**Jacob's Landing
Stream Restoration Monitoring Report
DMS Project # 95024
DMS Contract # 003984
Monitoring Year 04**

MEMORANDUM

Subject: Jacob's Landing Stream Restoration Site
MY-04 Monitoring Report Comments
Yadkin River Basin CU 03040105
Rowan County, North Carolina
NCDMS Project # 95024
Contract # 003984

Please find below our responses in italics to the MY-04 Monitoring Report comments from NCDMS received on January 19, 2018, for the Jacob's Landing Stream Restoration Site.

Longitudinal Profile
Jacob's Landing
DMS Project Number - 95024
Station 10+50 - 24+00 (T1)

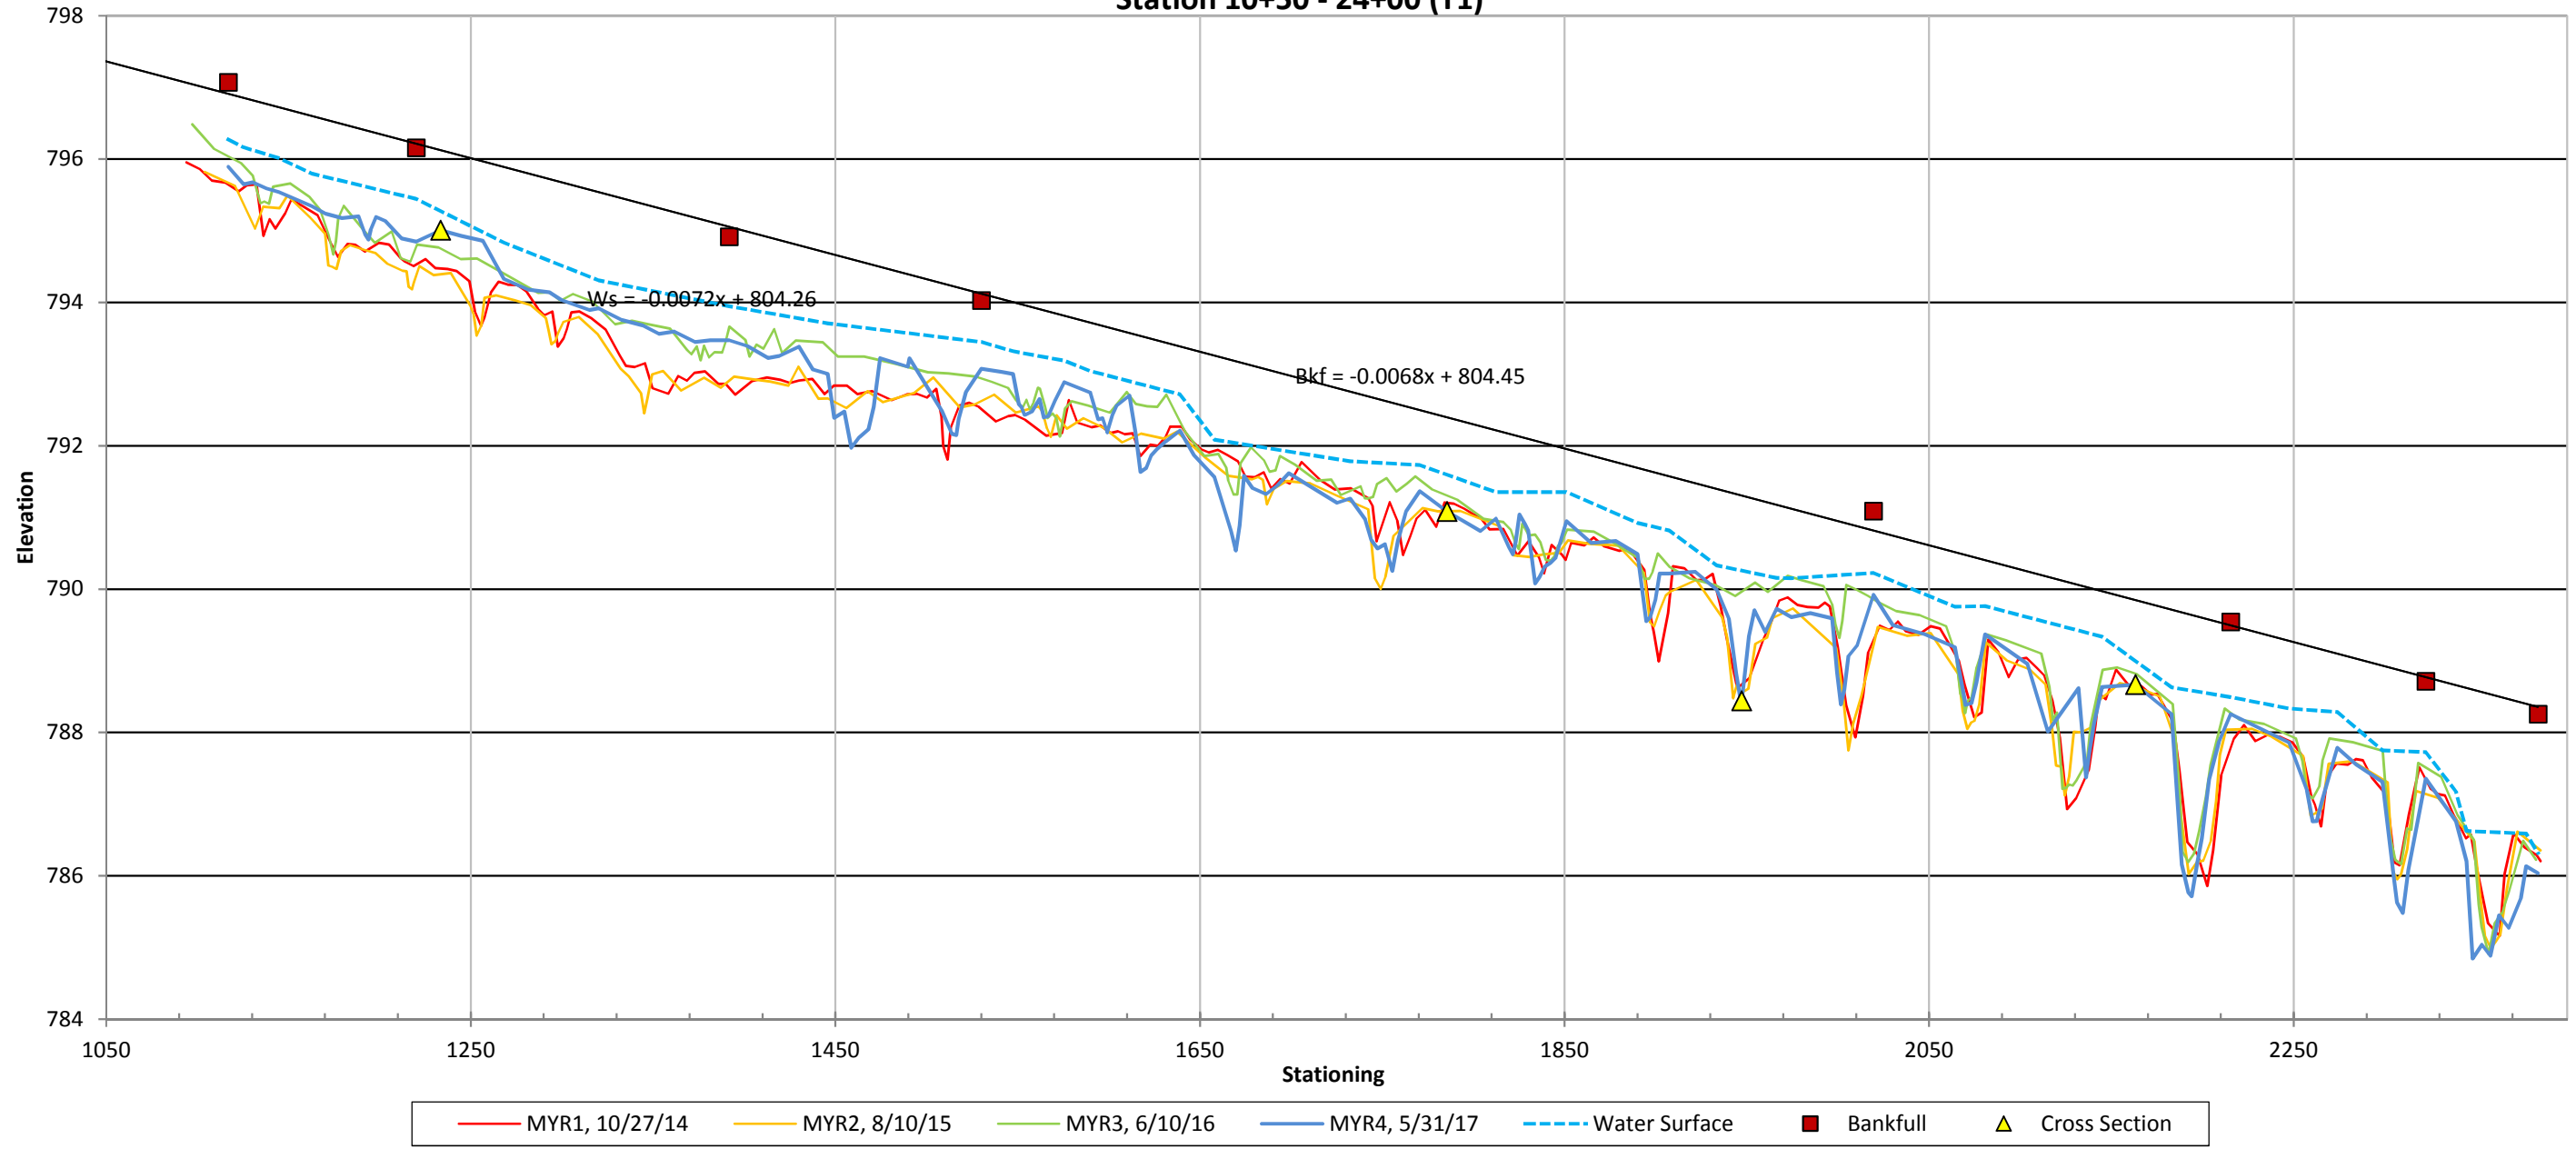
- Executive summary discusses aggradation on T1. According to the profile and Table 5, there appears to be approximately 550' of aggradation at the upstream section of T1. Please be aware that if a stream fills in and is not functioning as designed, the IRT may deny credit for this section. DMS recommends requesting site visit with IRT to discuss and develop an adaptive management plan if necessary.

- *KCI will request a site visit with the IRT.*
- All four of the failing vegetation plots are on Reach T2. Does KCI plan to replant portions of this reach?
